November 28, 2016
NND-16-0468
10 CFR 50.90
10 CFR 52.63

Virgil C. Summer Nuclear Station (VCSNS) Units 2 and 3
Combined License Nos. NPF-93 and NPF-94
Docket Nos. 52-027 & 52-028

Subject: VCSNS Units 2 & 3: Request for License Amendment and Exemption: ADS and IRWST Injection Block (LAR 16-15)

UFSAR Section 7.2. Figure 7.2-1. Sheet 15 of 21 (changes reflected in clouded areas)

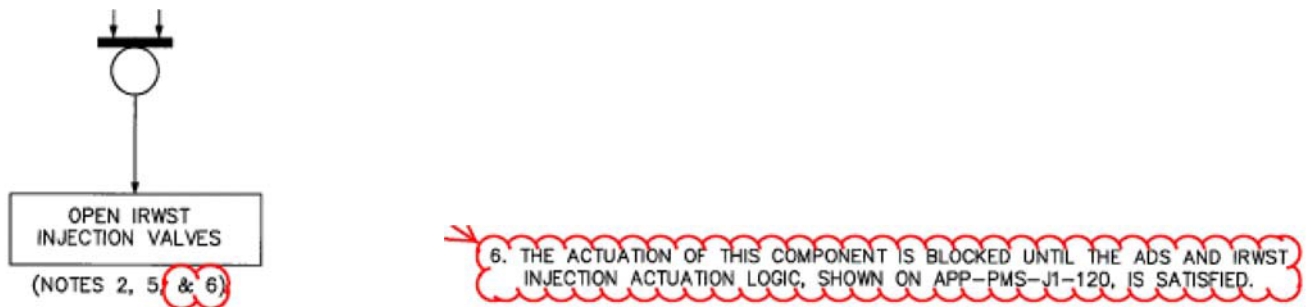
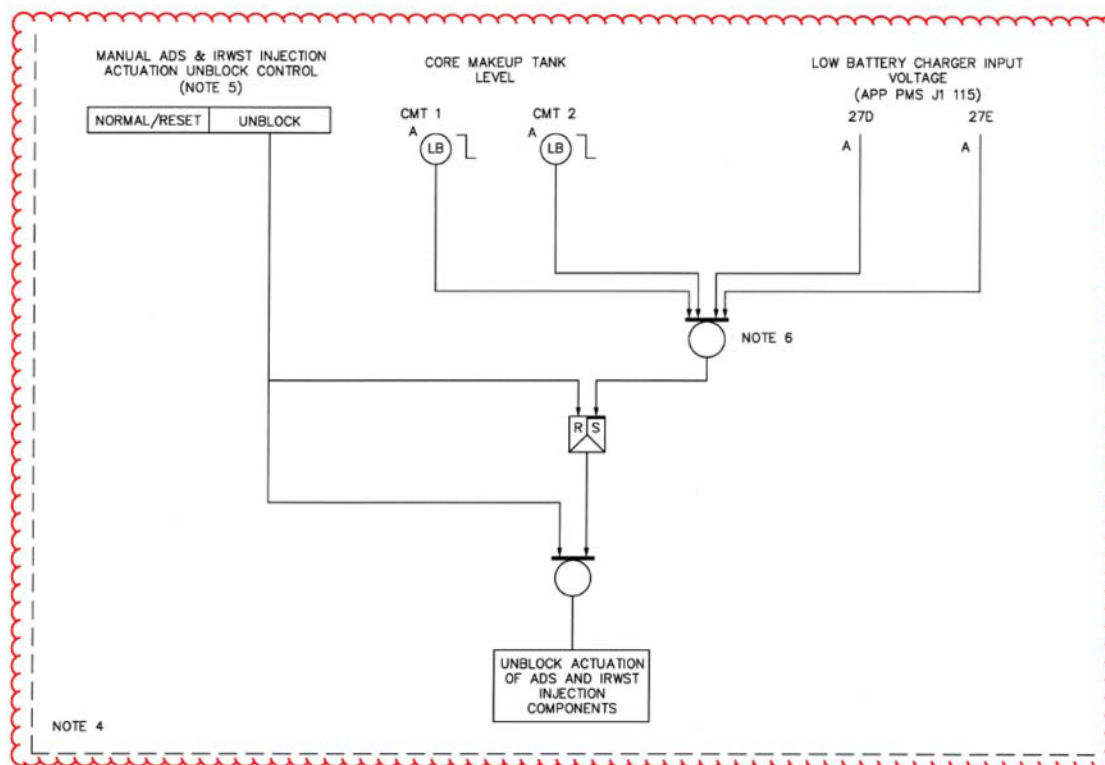
The low CMT level signals, the low battery charger input voltage signals, the manual unblock signal, and the remote shutdown workstation (RSW) transfer signal are logically OR'ed (OR logic gate) together in the circuitry of the ADS and IRWST injection blocking device in each division. The result of this OR'ing is used to remove the block signal to the CIMs. This design feature is reflected in the proposed revision to UFSAR Figure 7.2-1 (Sheets 15 and 19).

Table 3, Proposed Tier 2 and Tier 2* Licensing Basis Changes	
Text, Table, or Figure	Description of the Proposed Change
Figure 7.2-1, Sheet 19 of 21, "Containment Vacuum Relief Protection"	<ul style="list-style-type: none"> Added new logic to show how the ADS and IRWST injection block and unblock signals interface with the PMS. Three inputs are shown (Manual ADS and IRWST Injection Actuation Unblock Control, Core Makeup Tank Level, and Low Battery Charger Input Voltage) which, when actuated, unblock actuation of the ADS and IRWST injection components. Added Note 4 to state that the logic is implemented without using computer software. Added Note 5 to state that separate controls are used one in each division, to manually unblock the ADS and IRWST injection actuation blocking device. Added Note 6 to state that the MCR / RSW transfer switch also unblocks the ADS and IRWST injection actuation blocking device when control is transferred to the RSW.

(Existing Note 8 is replaced with the above Note 8)
